IREDELL COUNTY HEALTH DEPARTMENT

IMPROVEMENT PERMIT / AUTHORIZATION TO CONSTRUCT / OPERATION PERMIT / EXISTING SYSTEM INSPECTION

PERMIT# 122764 PIN# ~~4636-39-9719.000~~ 4637-40-4228 DATE Jan 20, 05

SUBDIVISION Edgewater Park BLOCK / SECTION 3 LOT 44 LOT AREA .716 ac SITE CLASS. PS DESIGN FLOW 480 gpd L.T.A.R. .3

AS BUILT SKETCH

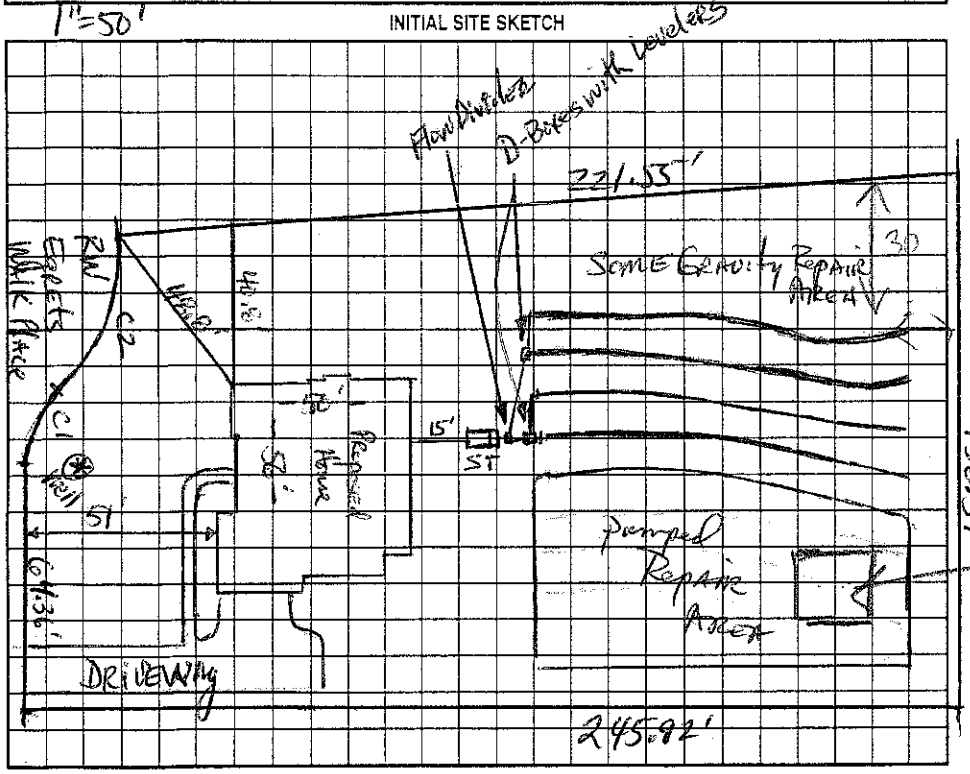
Comments:/Conditions:
Do not cut / lower house site

Comments:/Conditions: ST 20' off House, 8' off Deck

Location of the proposed Shed addition does not appear to impact the existing on-site septic system.**NOTE: Keep Bldg at least 5ft from Septic System
